REQUEST FOR INFORMATION DATE: August 11, 2016 NO.: RFI-239

Project Name: 15051-Webster University Interdisciplinary Science Building Project No.: 15051

Subject: ASI 3 Clarifications

SUBJECT
MADE BY DUMPSTER SCREEN WALL

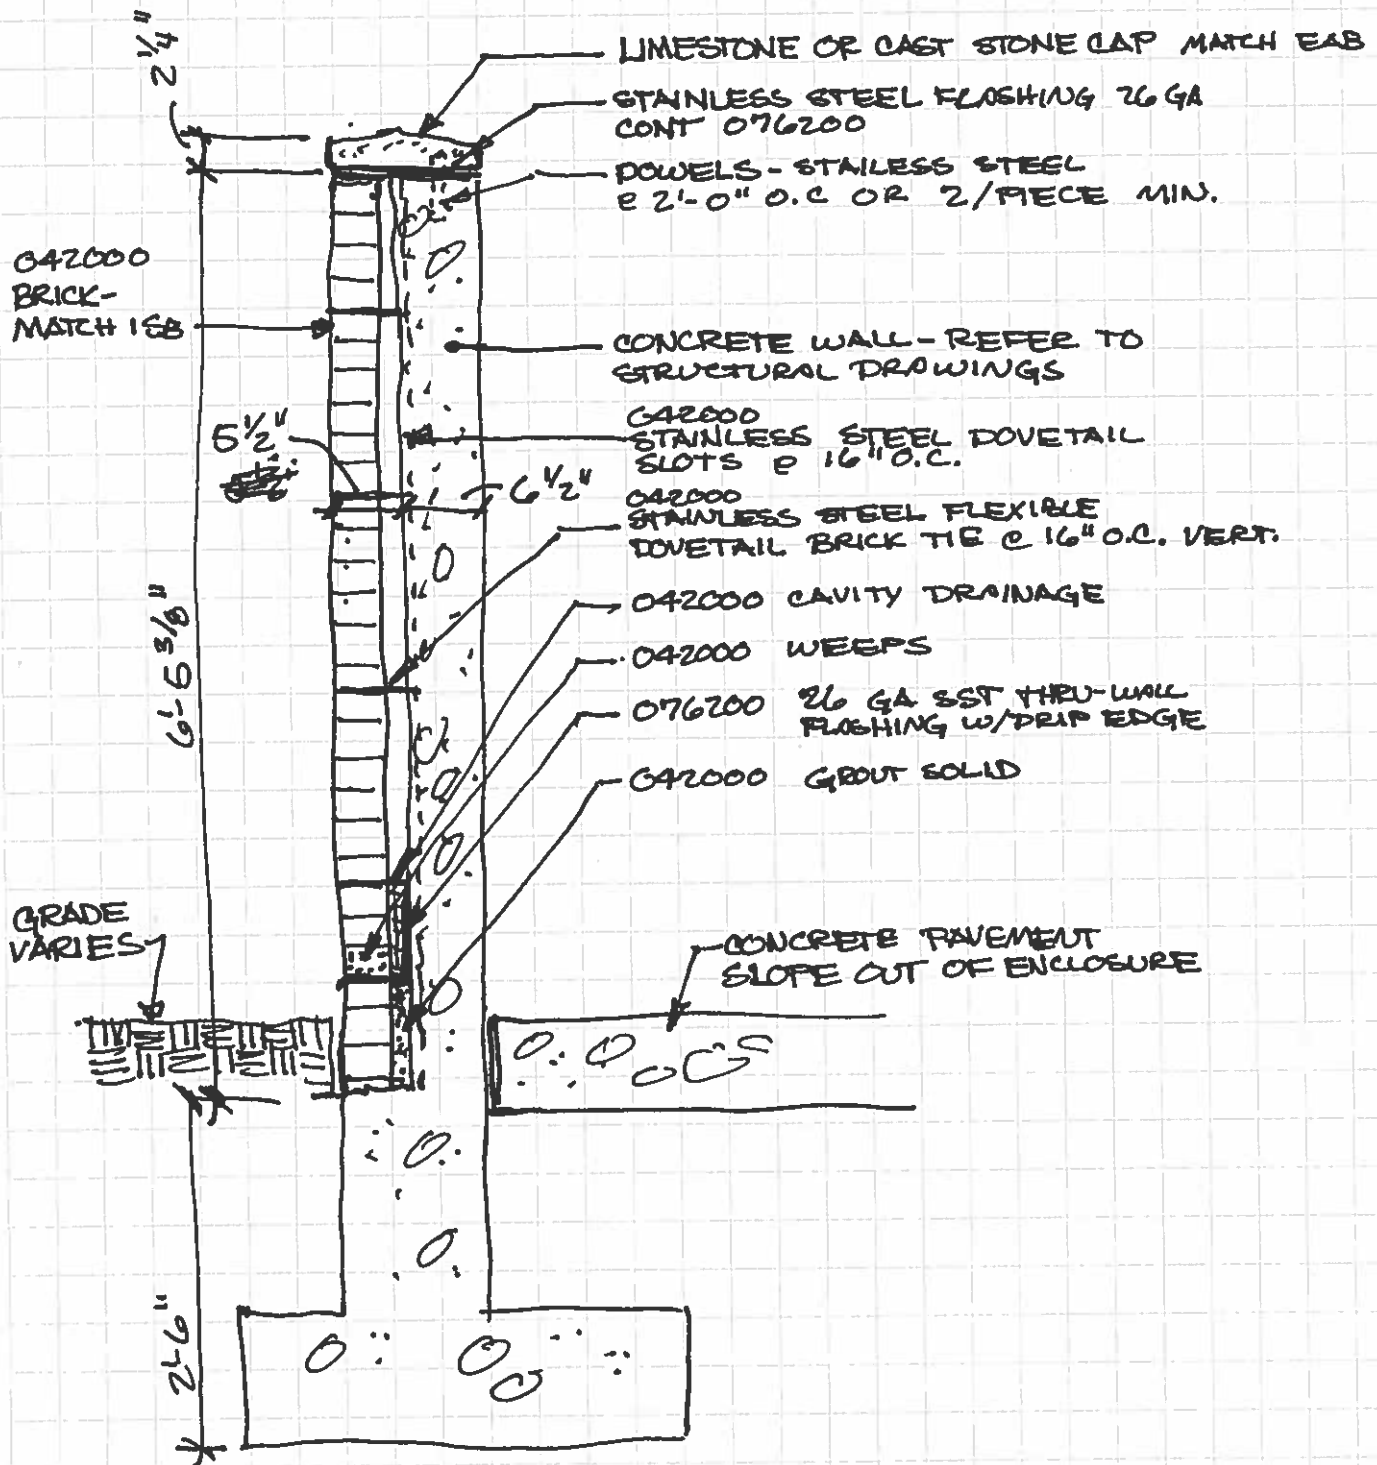
1. Please provide structural details (width, depth and any reinforcing req'd) of the landscape seat wall in 1/A0507.B and 1/A508.A
2. Please provide structural details of the stair walls 2/A0507.A. The typical structural details on S0003 refer to a single retaining wall only, not a double condition. Detail 5/S0003 is a similar condition, but is designated for only 6'6" in height which exceeds the stair wall height
3. Please provide structural and architectural details of the dumpster enclosure walls. Note A.12 on A0101.A does not indicate top of wall height. Are walls CMU with brick veneer?
4. Please advise of "formliner finish" desired for walls indicated throughout ASI 3.

- 1., 2 and 3. Refer to ASI 007 for requested structural clarifications. and refinements.
3. Height - refer to ASI 007. Walls are concrete with brick veneer per ASI 007. Length and width to be determined with input for dumpster sizes from Webster University. (Architectural sketch detail is attached.)
4. Formliner finish: Provide cost options for each of the below:
 - Option 1: Use formliner similar to Fitzgerald pattern 14386 with fluted ribs 12" oc. oriented vertically. (Info attached)
 - Option 2: Per contractor suggestion use wood forms to create the smooth ribbed finish matching the formliner indicated above. Provide photo examples of how the contractor has executed this in past experience and provide a mock-up for final approval.
